APPENDIX III- ANONYMOUS PEER-REVIEW COMMENTS ON "A SYNTHESIS OF THE COAST-WIDE DECLINE IN SURVIVAL OF WEST COAST CHINOOK SALMON"

Responses to 5 Reviewers and editor's comments from two rounds of reviews at Fish and Fisheries. (Our detailed responses describing how we modified the manuscript are also included).

I write to you regarding manuscript # FaF-20-Mar-OA-084 entitled "Review of the Coast-wide Decline in Survival of West Coast Chinook Salmon (*Oncorhynchus tshawytscha*)" which you submitted to Fish and Fisheries.

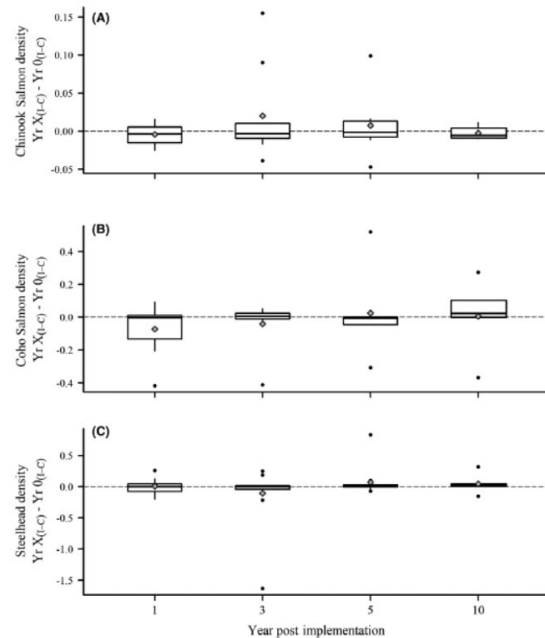
Line 126. "If survival across this vast swathe of relatively pristine territory is severe enough to seriously impact salmon productivity, then there is little hope that modifying freshwater habitat in more southern regions will support a newly productive environment for salmon." This seems logical, but I don't think most people involved in stream restoration are aiming for a "newly productive environment". They are aiming to increase the

number of smolts that migrate to the sea, in the hopes that this will lead to stronger adult returns. If ocean survival is cut in half, then if twice as many smolts leave, that MIGHT mitigate the reduced ocean survival, though this depends crucially on the fitness of the smolts when they leave (e.g. reduced survival from hatcheries) and on negative density dependence, which could be severe if the ocean's carrying capacity is lower. All of this is just to say that the wording should be chosen carefully, in terms of objectives and caveats.

**Response: If the freshwater habitat modifications won't produce a "newly (more) productive environment" that increases the number of smolts produced, then it is difficult to see how the people advocating for this work are going to generate more smolts to offset the decline in marine survival.**

The reviewer's comment is a common response I have seen over my career, where freshwater habitat specialists call for more (freshwater) habitat work but then often fail to change smolt numbers... the habitat is "prettier" (or fits what human eyes see as "more natural", and thus beautiful) but this does not translate into more smolts out—which is the key. As a particularly important example of this, consider a 10 year Washington State study published this February using treatment and control groups to evaluate the improvements in smolt production resulting from a \$1.5 Billion US habitat improvement effort. (See Krall, M., Clark, C., Roni, P., & Ross, K. (2019). Lessons Learned from Long-Term Effectiveness

The authors of that study convincingly demonstrated that there was essentially zero (no) difference in smolt numbers between the multiple replicated treatment/control comparisons conducted at any point in the decade-long monitoring program (Fig. 3 of that report, reproduced here). Yet they never concluded that the habitat restoration work was ineffective in increasing the number of smolts produced for any of the three species of salmonids monitored at any of the 4 time periods it was assessed (what their study demonstrated). Instead they concluded that the study must have been statistically underpowered, which was not true, as their own graph clearly demonstrated! (The differences in all cases were near zero, as opposed to large differences but with large variance).

This is why our paper is important—we are showing that the marine survival declines are large and the same (or closely similar) for a wide range of populations and habitats—including essentially pristine (northern BC, SE

Alaska and (now) Russia). I don't think it is appropriate to hammer on this point that the reviewer makes further in the paper, but it is something I intend to pick up on in a separate paper dealing with the point that the effect of freshwater habitat improvements on smolt numbers is rarely measured, but where it has been there is little evidence that it has had the intended effect of increasing smolt numbers.
